## SAWS DOS RIOS SLUDGE BLEND FACILITIES EXPANSION PROJECT

Solicitation Number: CO-00080

### ADDENDUM 1

September 22, 2016

SHEET **E-08**  
46 OF 54

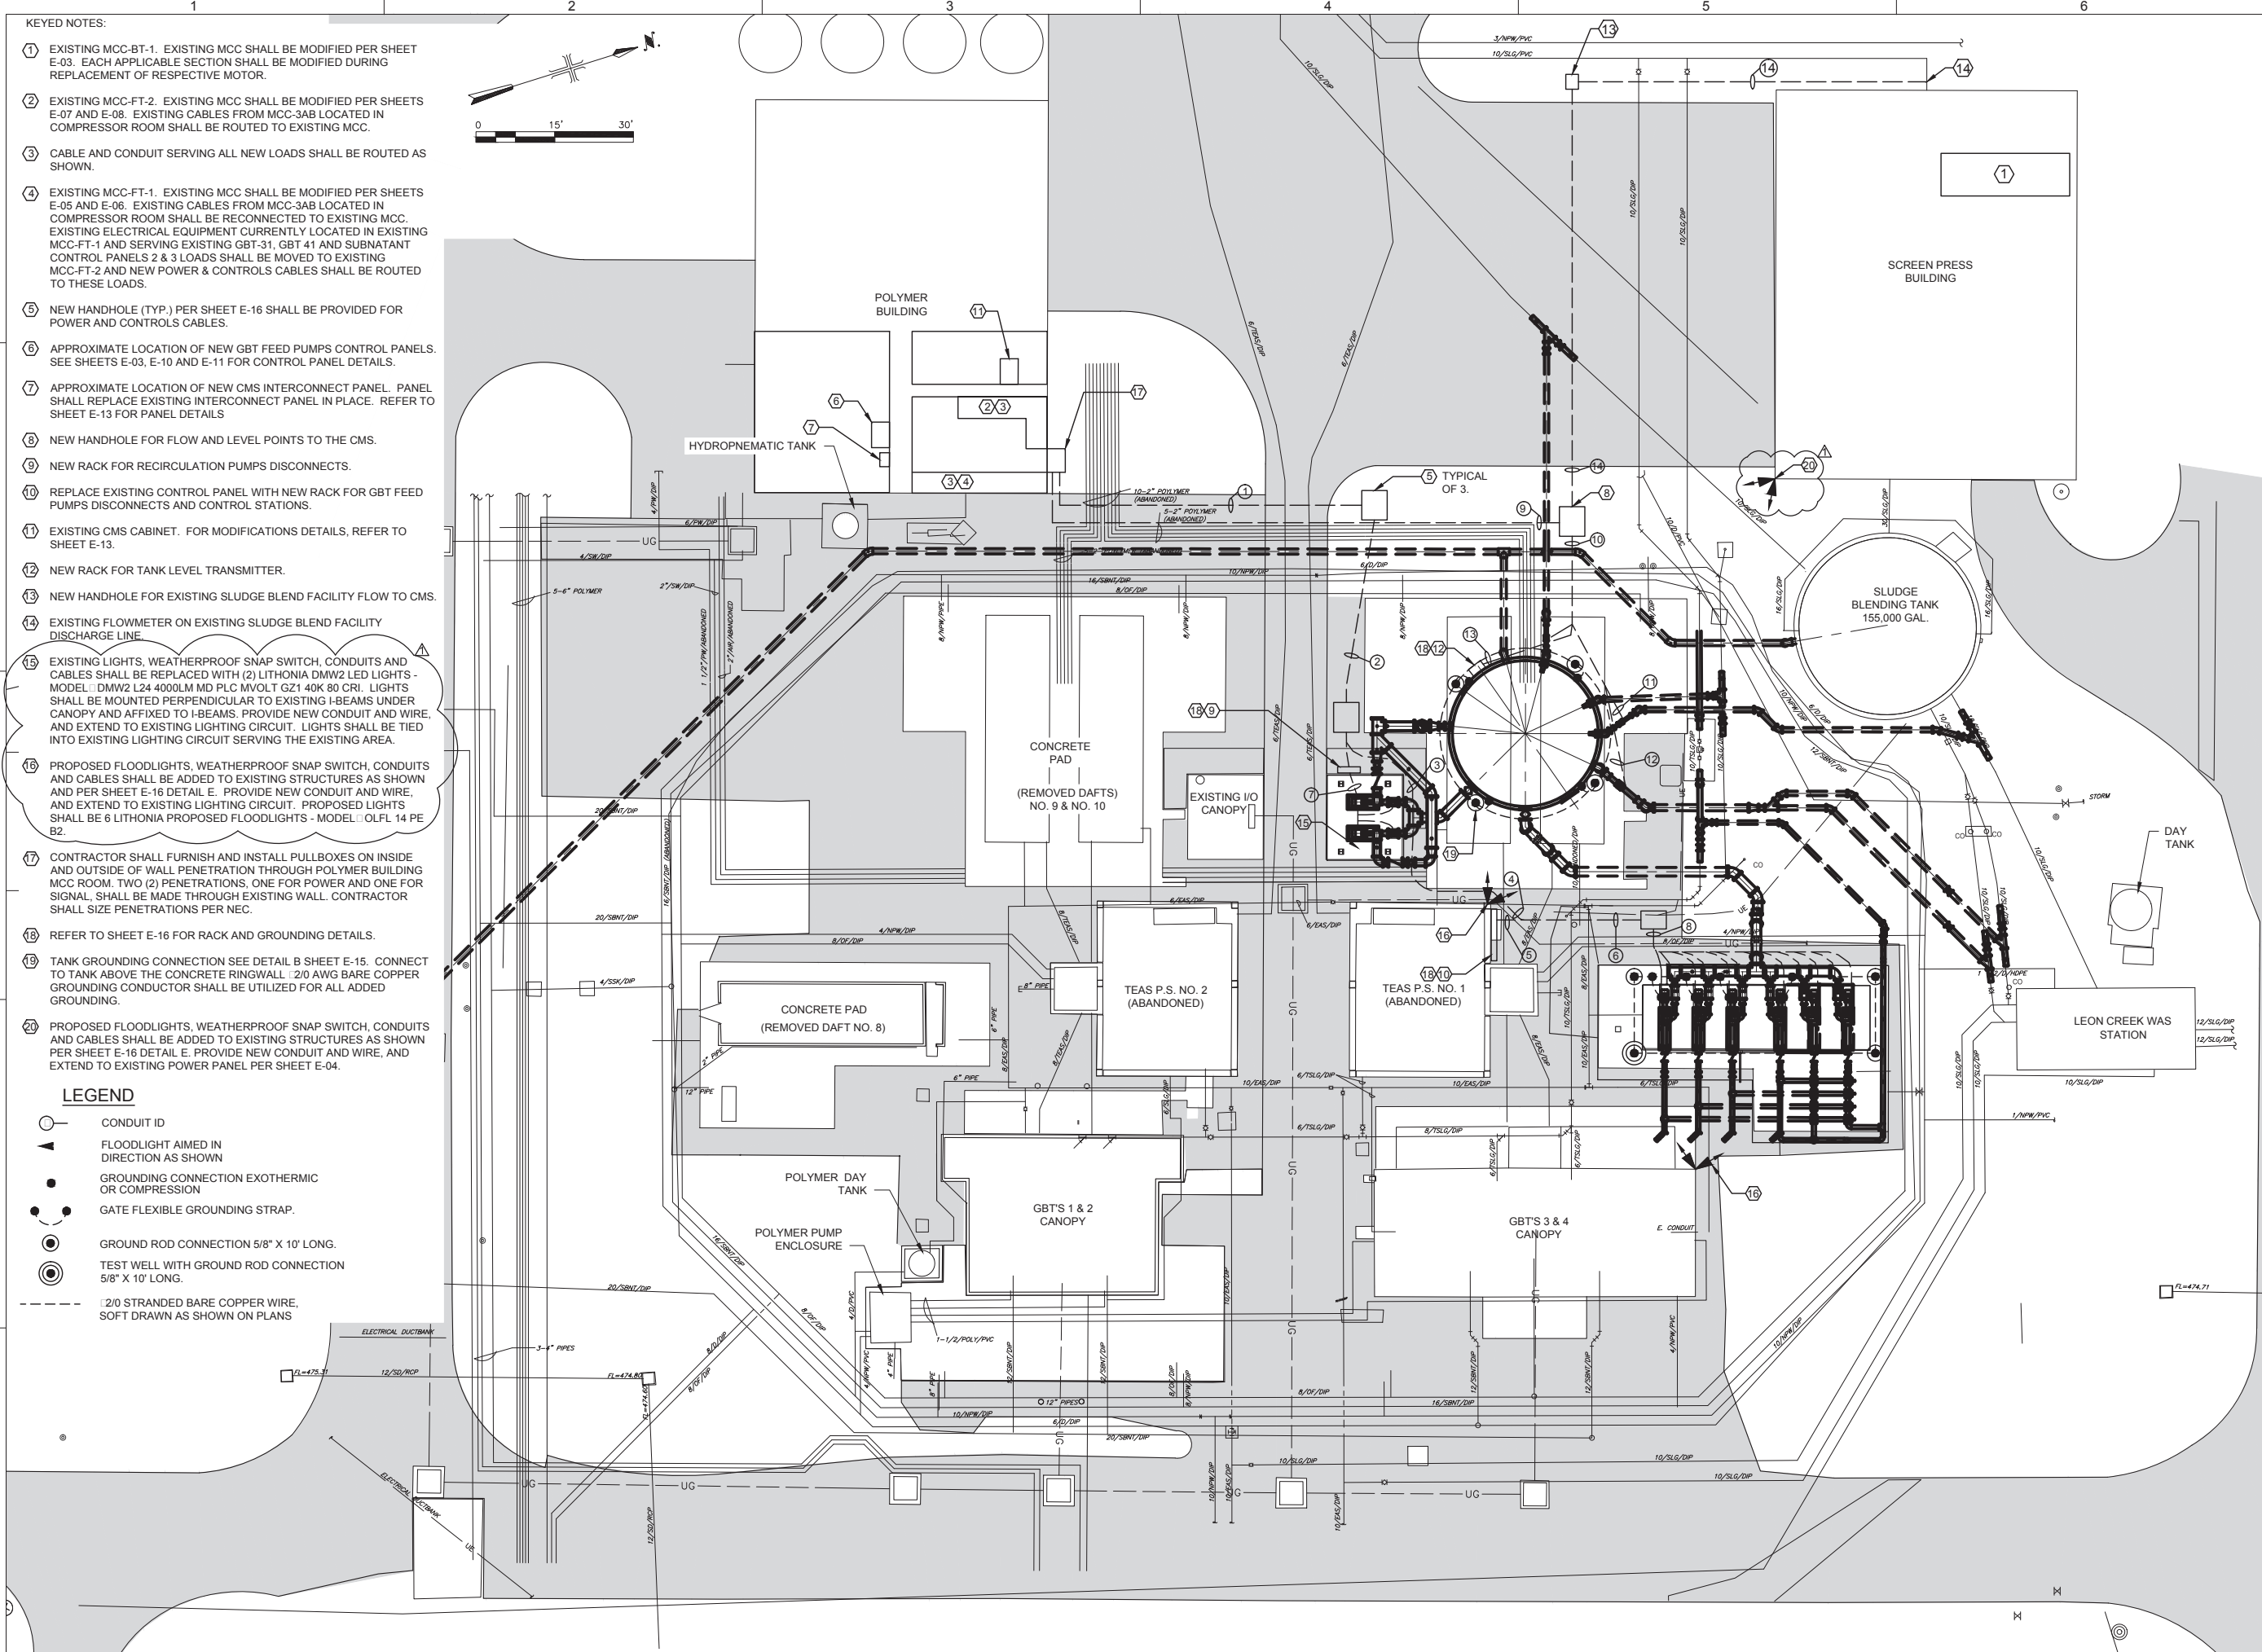
**15. Sheets E-06 and E-08 shows we are to replace the existing ASCO ATS in MCC-FT1 and MCC-FT2. It appears we are to replace the conductors from the ATS to the generator paralleling gear? How do we quantify the amount of wire that will be needed to replace the conductors? Is the existing raceway currently empty? Is the conduit new?**

Response: Yes, the conductors shall be replaced. Only conductors shall be replaced per revised sheets E-06 and E-08.

SHEET **E-12**  
50 OF 54

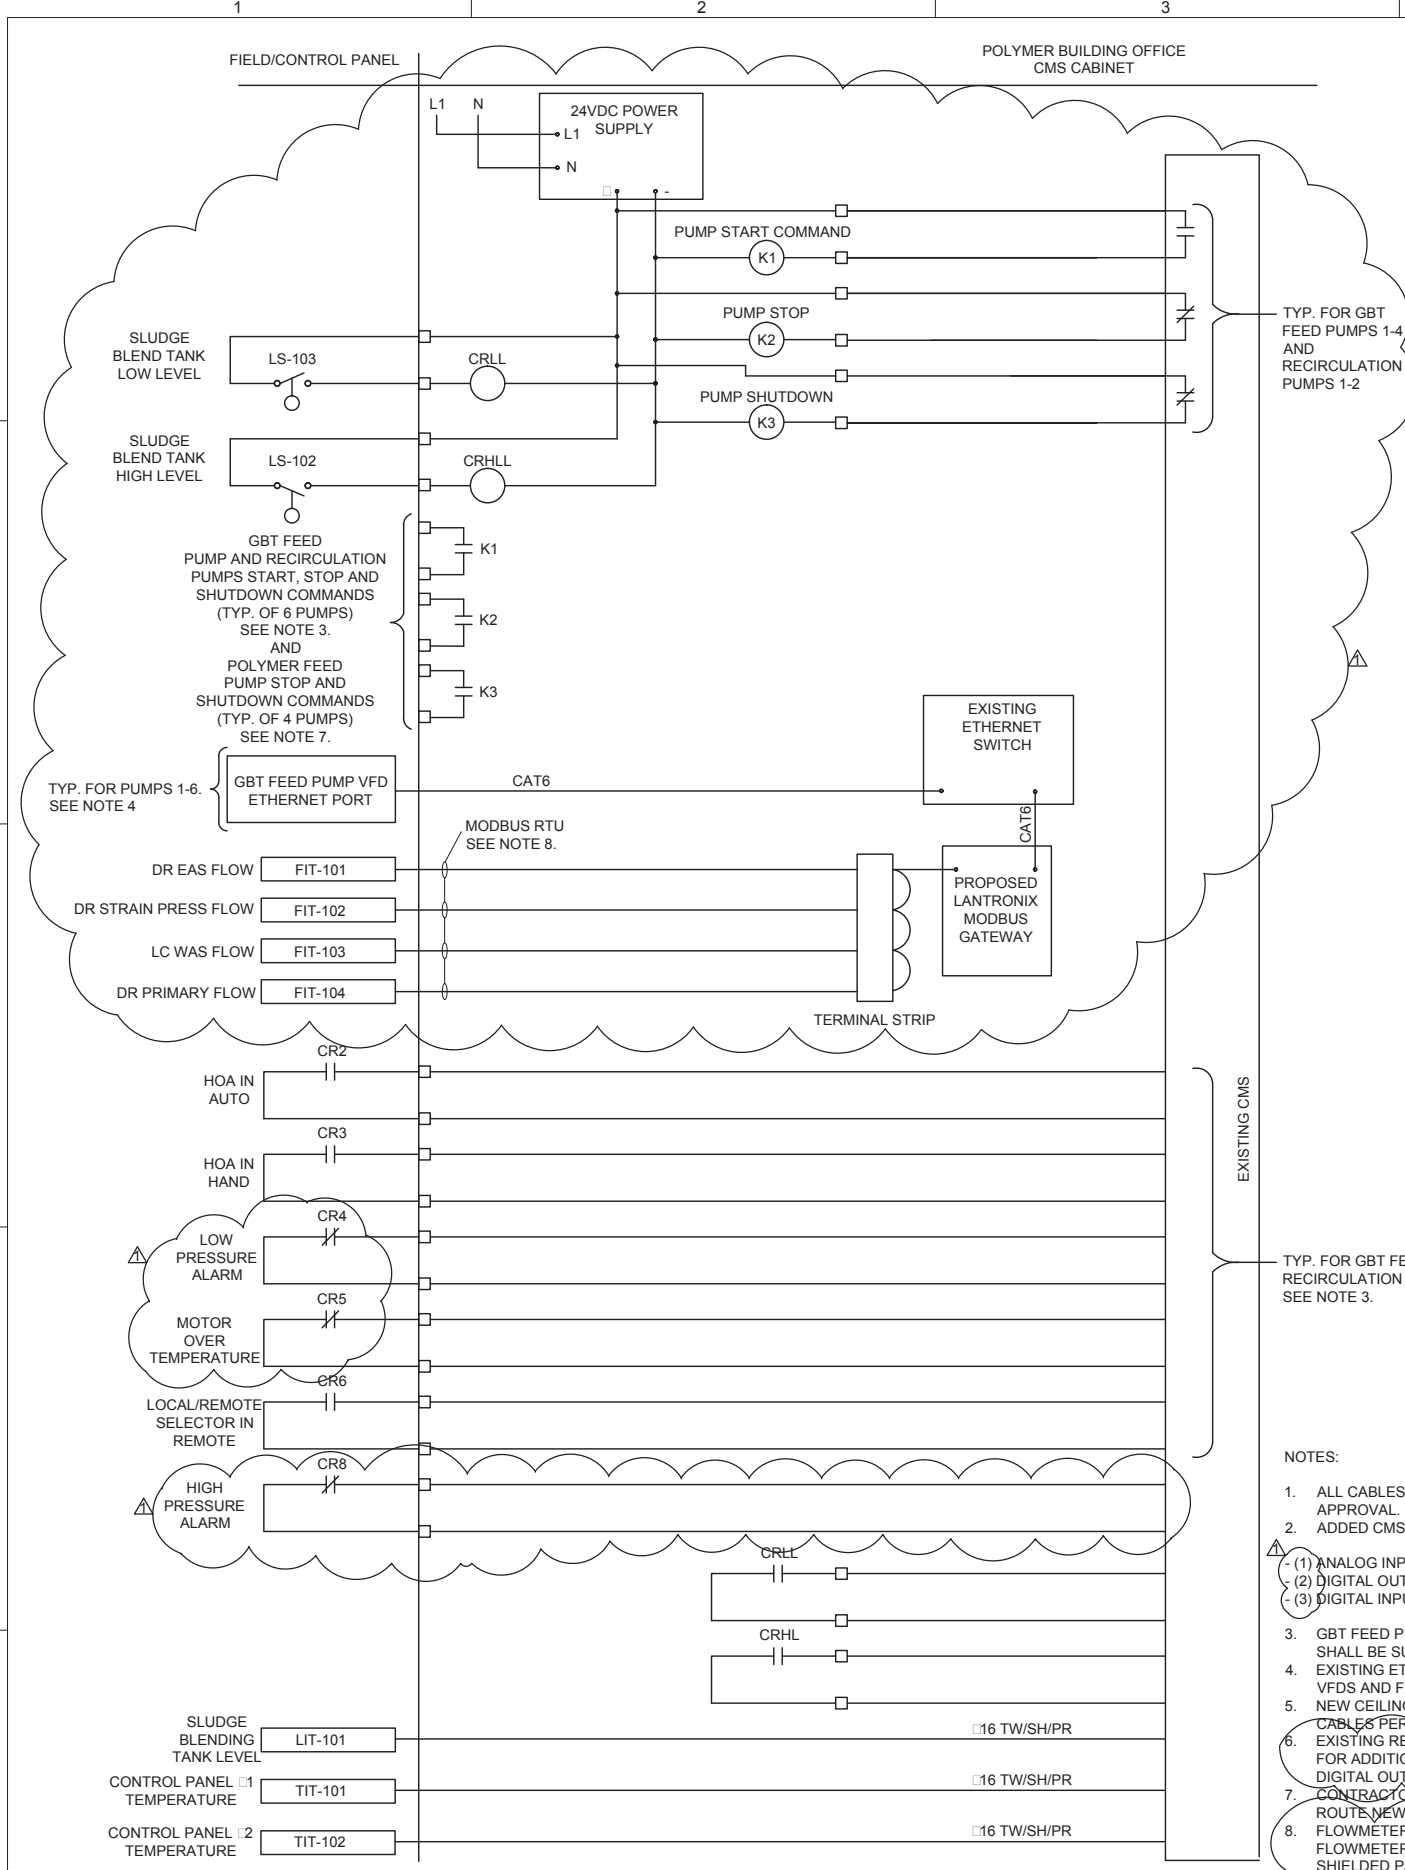
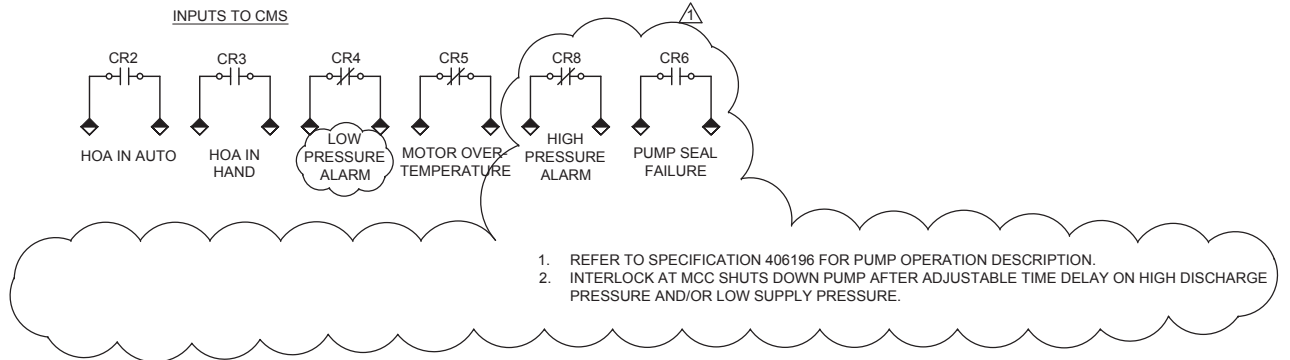
- 6. Is a moisture probe located within the oil bath connected to a sensor relay acceptable in lieu of a visual sight gauge detailed in specification 43 21 13.2.3.A.8?**

Response: Yes. An additional alarm and shutdown control point will need to be provided in addition to this as well though. Refer to updated Sheet E-12, which is included as part of this Addendum No. 1.
